Owner Change Order (OCO)

Project Name: Brookline - Driscoll School
Gilbane Job No.: J08864.000

OCO: OCO-0006

Description: This OC contains the following approved PCI/ATP's:
OS 00020/ ATP 14 Rev 1 ASI 4 Waterproofing
OS 00028/ATP 16 Credit for Painting of Map
OS 00022/ ATP 17 ASI 6 RDP Coordination
OS 00019/ATP 19 ASI 2 Stair 5 Structural Revisions
OS 00037/ATP 20 Rev 1 PR006 Admixture at Concrete Elevator Pit

1 ASI #006 - CORRIDOR 0030 RADIANT PANEL REVISION
 1/8" = 1'-0"

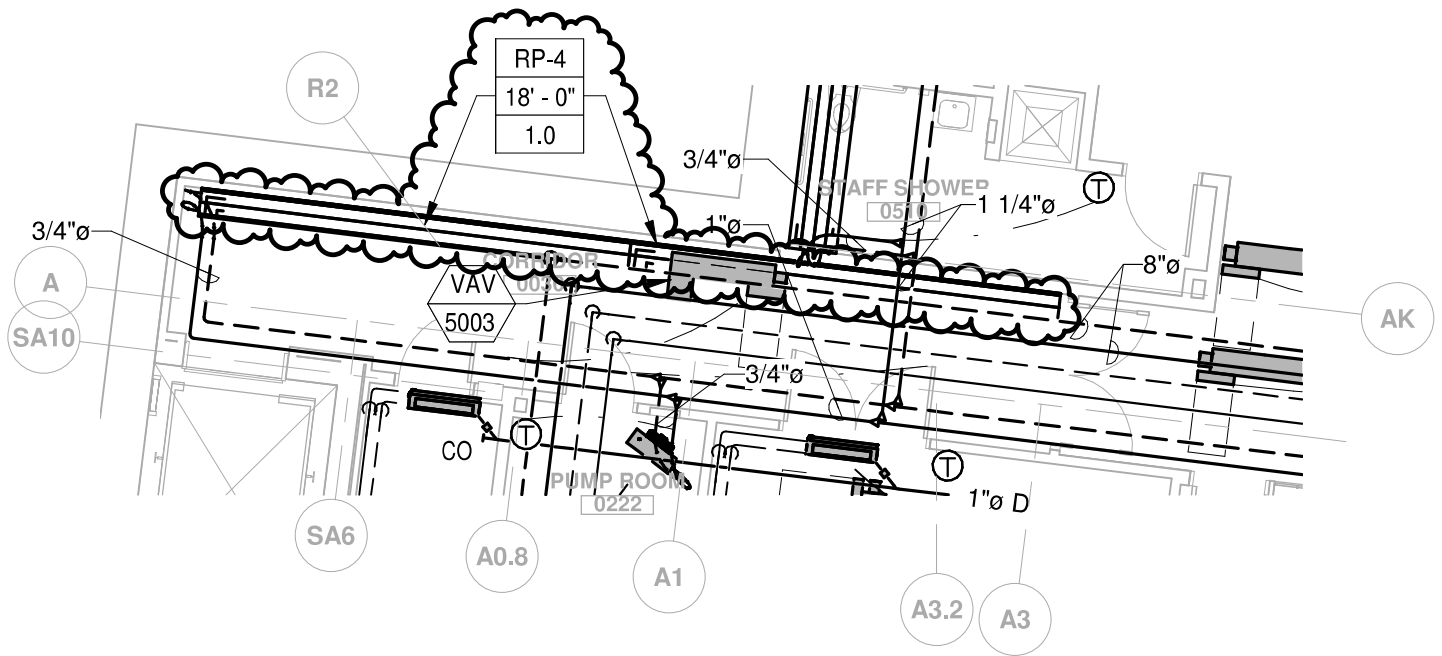
- SK A 014 RCP/HVAC clarifications – FL0
- A180A Reflected Ceiling Plan – Floor 0-A
- A180C Reflected Ceiling Plan – Floor 0-C

Project	TOWN OF BROOKLINE DRISCOLL SCHOOL
Sketch Title	FRAMING PLANS FLOOR 3 - A AND FLOOR 4 - A

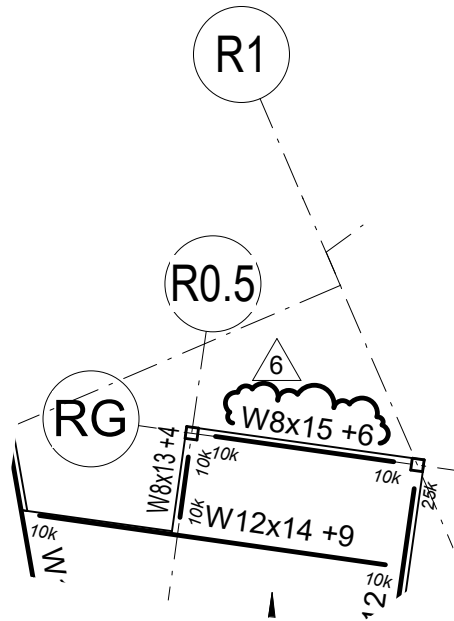
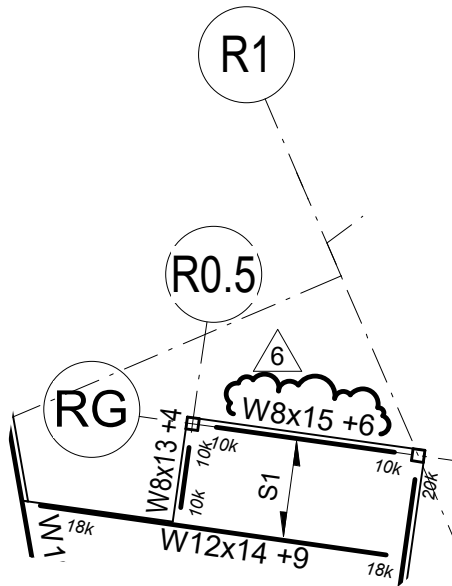
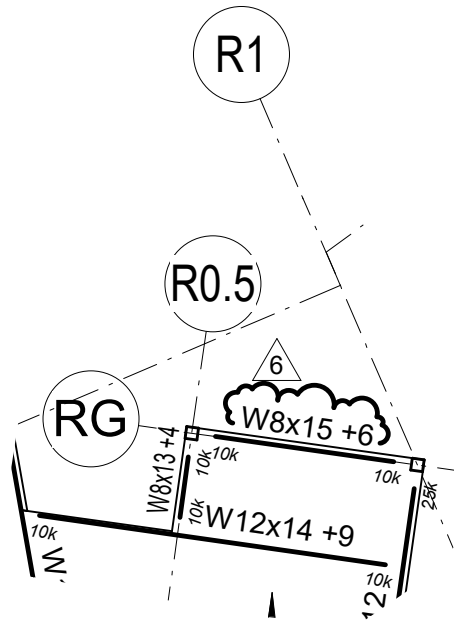
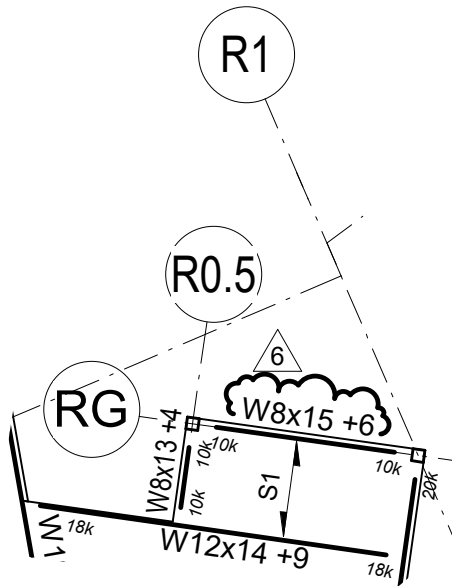
Provide landing structure and revisions at stair 5 first floor level as shown per attached sketches.

1. S100C and 2/S306: Line CY ONLY: locate west edge of wall footing 5'-10" west of line CY, locate east edge of wall footing 5'-10" east of line CY. (CM request.)
2. Revise slab on deck span direction arrows between lines CR/CU and CX/CZ to be parallel to line C.
3. Beam at column C25-CS.9 shall be a W6x12+8 on line CS.9 from C23 to C25.
4. 1/S304: Inside FOW shall be 2 1/2" south of line AR.
